Substantive response of the Local Highway Authority to a planning consultation received under The Development Management Order.

Planning Application Number: 24/00274/FUL

Application Address: Manor View Aston Flamville Road Burbage Hinckley Leicestershire LE10 3AA

Description of Application: Re-consultation. Extensions and alterations of existing ancillary building to form early years day nursery (Class E) with associated car parking

Figure 1: Northwestern visibility splay.

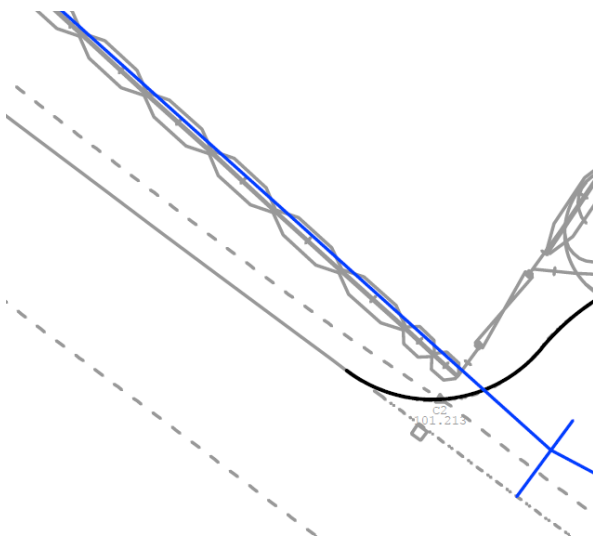
The LHA previously advised to the northwest, the visibility splay appeared to cross third party land i.e. the neighbouring field, and was obstructed by the existing hedgerow, which also restricted the available visibility on the site visit. The Applicant's revised drawing, which shows the visibility splays off-set 1.0m into the carriageway, still appear to show the visibility splay (blue line) falling within third party land and being obstructed by the neighbouring hedgerow, as shown in Figure 1 below.

- Further consideration of the site access in terms of visibility splays and the location
- Provision of an RSA1 for any new access proposals as well as a designer's response to any problems raised; and
- Consideration of the proximity of the roundabout proposed as part of application 23/00673/OUT.
